SAFETY RECALL BULLETIN

NHTSA RECALL 25V208

AUTOCAR, LLC DC-2503

Autocar, LLC has decided that a safety defect exists with the blower motor circuit protection fuse on certain 2020-2026 model year DC (Legend) vehicles.

Figure 3

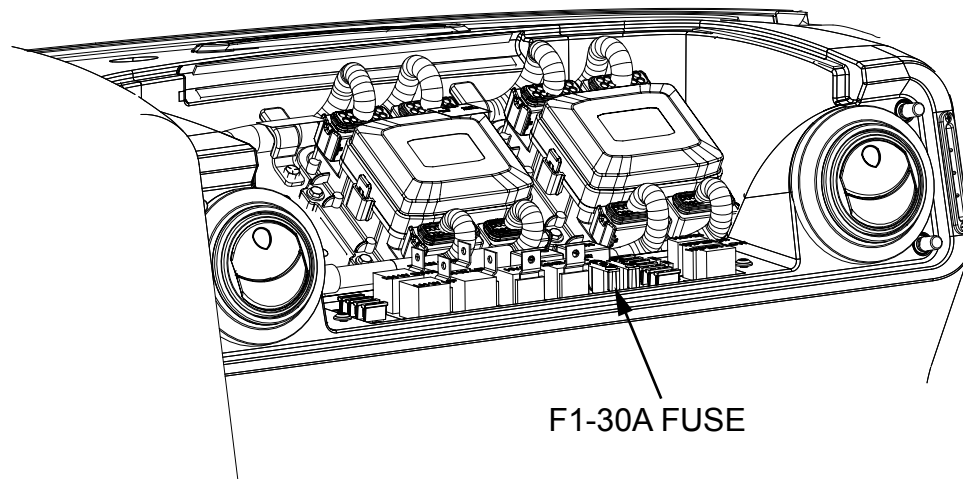
5. Remove and discard the F1-30A fuse from the fusebox 3 (FB3) (see *Figure 3*).
6. Install the A8700029-020, 20A fuse into the F1-30A location in FB3.

Figure 4

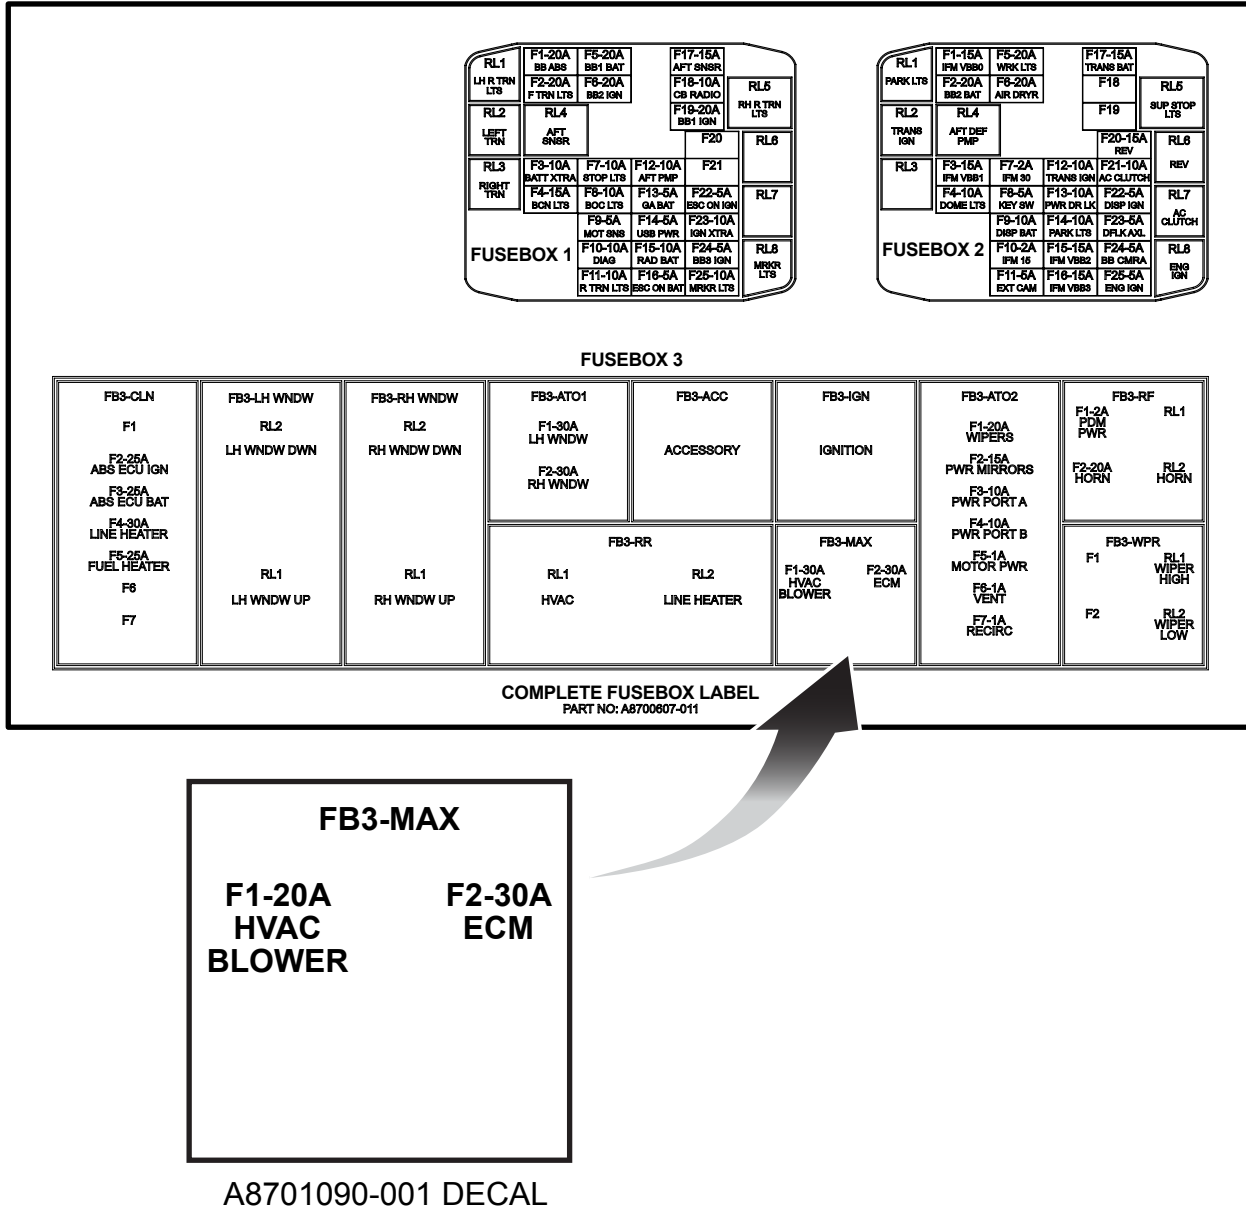
- Install the A8701090-001 decal over the existing fusebox 3 label at the F1-30A FB3-MAX location (see Figure 4).
